## TMC SPECIFICATION NO. S-579

TITLE: CHG-1 ALDC MODIFICATION KIT (TMC NO. KIT-109)

TMC Model CHG-1, (AM-2505/URA-31) Controlled Frequency Amplifier.

To provide an ALDC line into the CHG-1.

FIGURE 1

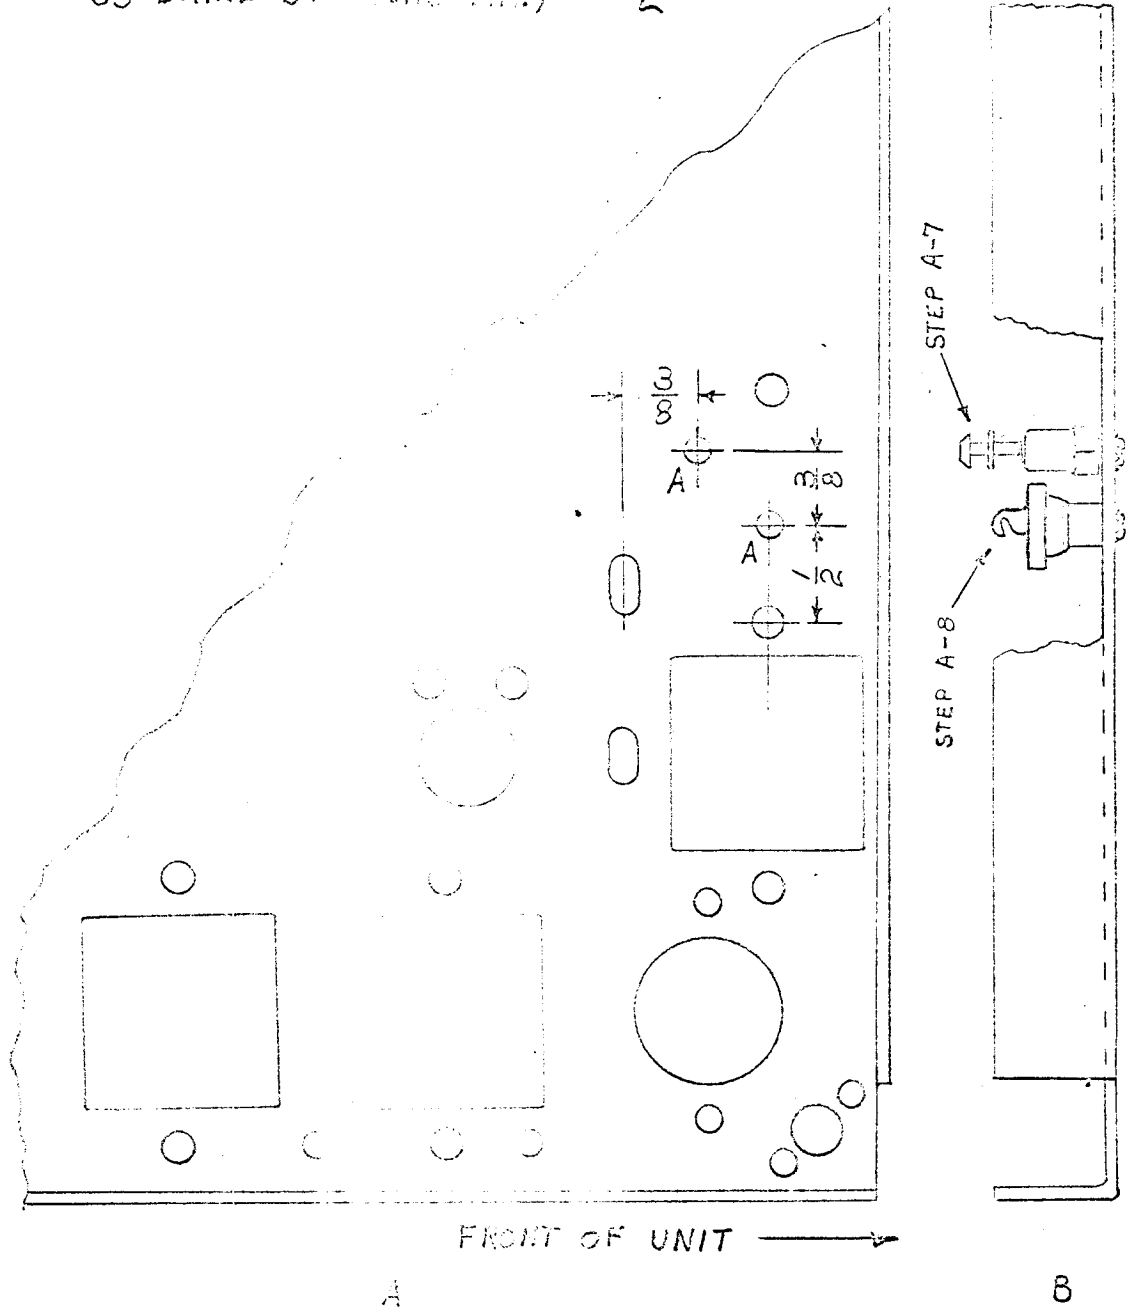
4. Mark appropriate spot on the chassis, for the drilling of the two holes used for mounting of the turret terminal and button capacitor (hole locating dimensions shown in Figure 1A).

6. Clean CHG-1 of all metal shavings resulting from the drilling. Be sure that nothing is shorting.
7. Mount the turret terminal (Item 2) by use of the 4-40 hardware (Items 7 & 9) as shown in figure 1B.

8. Mount the button capacitor (Item 5) by use of the 3-48 hardware (Items 8 & 10) as shown in figure 1B.
9. Mount the RF transformer (Item 6) in space vacated by T1101, as shown in figure 2.

FIGURE 2

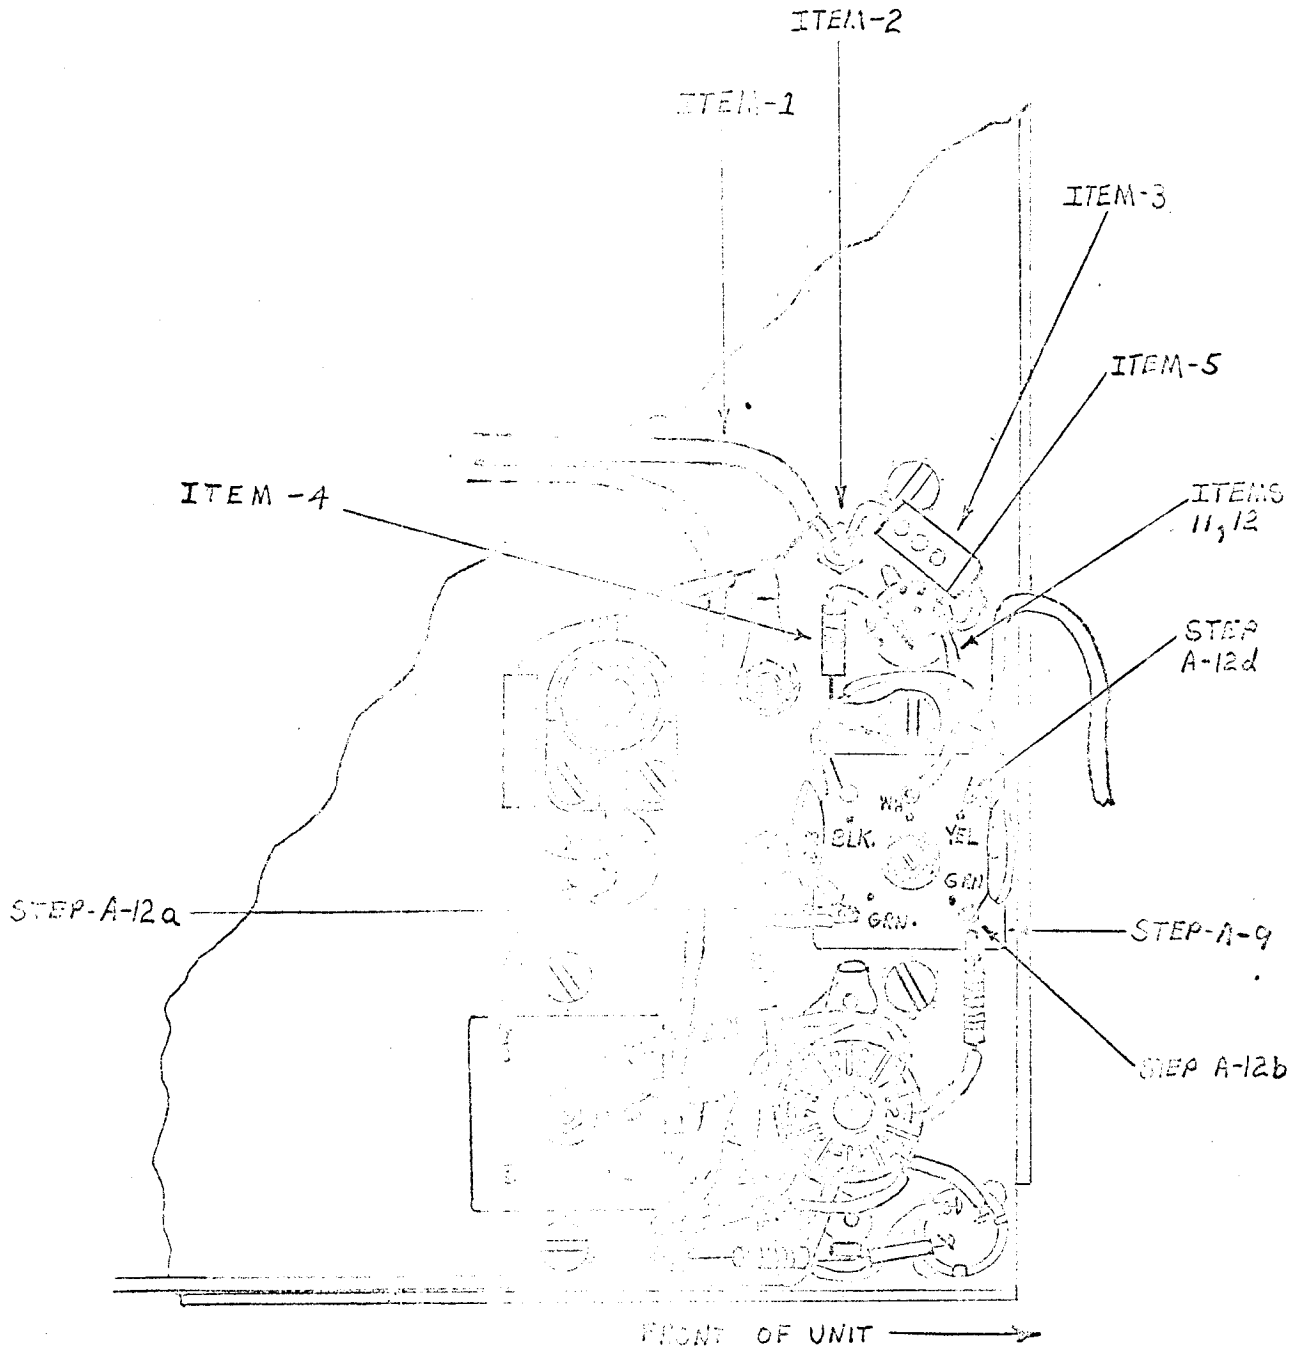
12. Make all connections to the RF transformer as follows.
  - a. Connect 39 ohm resistor (R1102) from pin 7 of V1101 to bottom left terminal (green dot) of RF transformer, as per figure 2. Next connect 3000 MMFD. capacitor (C1102) to junction of R1102 and RF transformer. Solder the junction point. Other end of (C1102) should still be connected to ground lug located where the RF transformer is mounted.

- b. Connect 39 ohm resistor (R1101) from pin 2 of V1101 to bottom right terminal (green dot) of RF transformer, as per figure 2. Next connect 3000 MMFD. capacitor (C1101) to junction of R1101 and RF transformer. Solder the junction point. Other end of (C1101) should still be connected to ground lug located where the RF transformer is mounted.

- c. Connect ground lead from ground lug to top left terminal (black dot) of RF transformer, as per figure 2. Solder connection.
  - d. Connect RC-174/U coax cable to top right terminal (yellow dot) of RF transformer as per figure 2. Solder connection. Shield lead of coax cable should still be connected to ground lug located where the RF transformer is mounted.

22. Connect center conductor of RF cable to turret terminal and solder. Also solder shield of the RF cable to a convenient ground point.
23. Check modifications to see that everything conforms with figure 2.

FIGURE 3\*

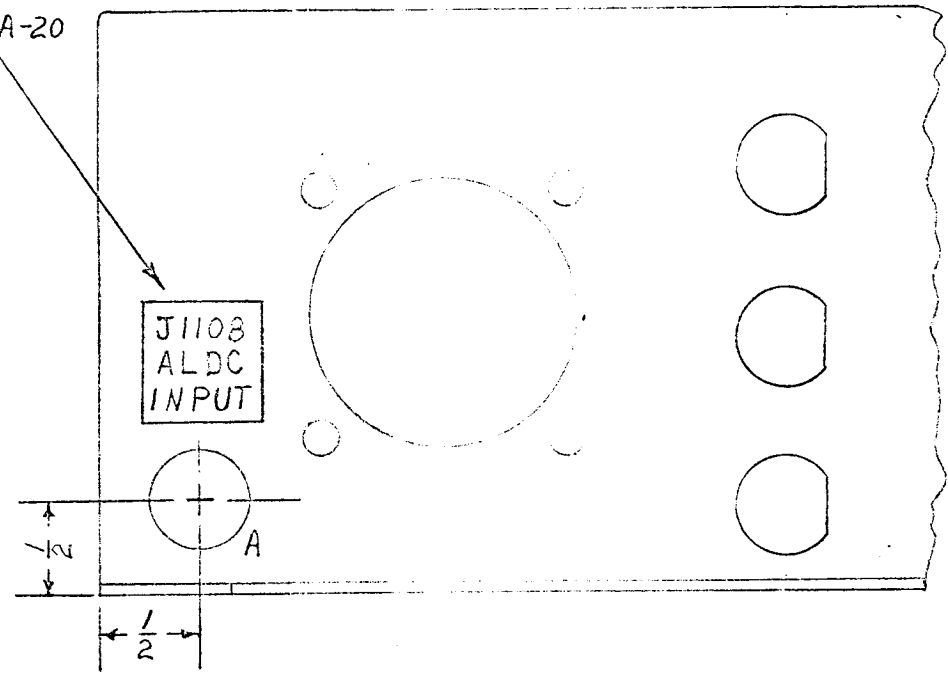
15. Mark appropriate spot on rear of chassis for drilling of the hole used for mounting JJ-172, (p/o CA-480-14-20, (Item 1) as shown in figure 3.

20. Affix instruction nameplate (Item 17) directly above the connector which has just been installed (refer to figure 3).
21. Thread RF cable attached to JJ-172 through grommet hole in plug shield. Keep the RF cable close to the chassis all the way to the turret terminal (Item 2).

FIGURE 4  
SCHEMATIC CHANGES

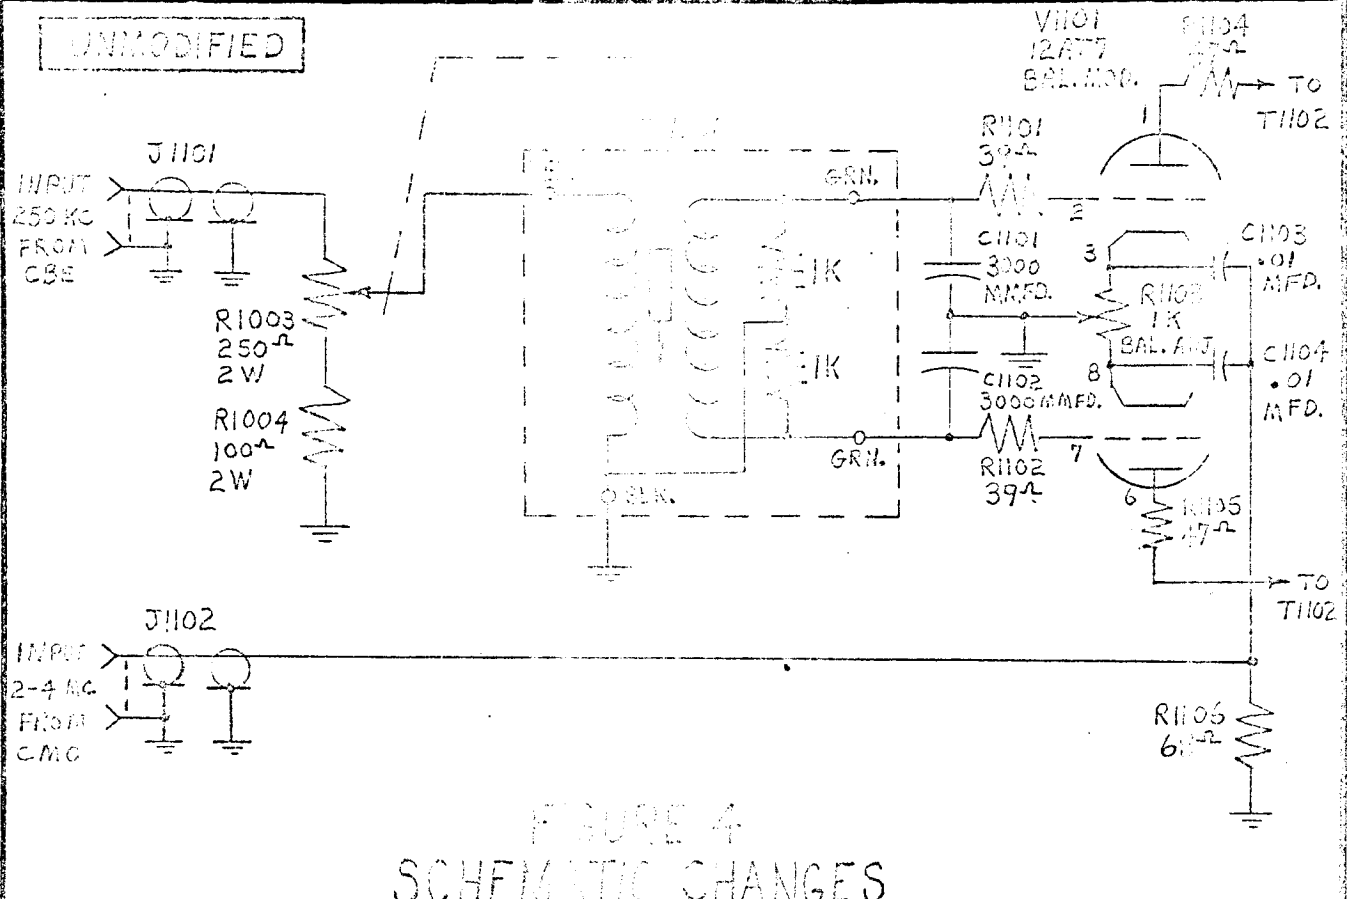
24. See figure 4 for schematic diagram.
25. After the CHG-1 has been checked to see that all the modifications have been properly installed, replace the top dust cover.
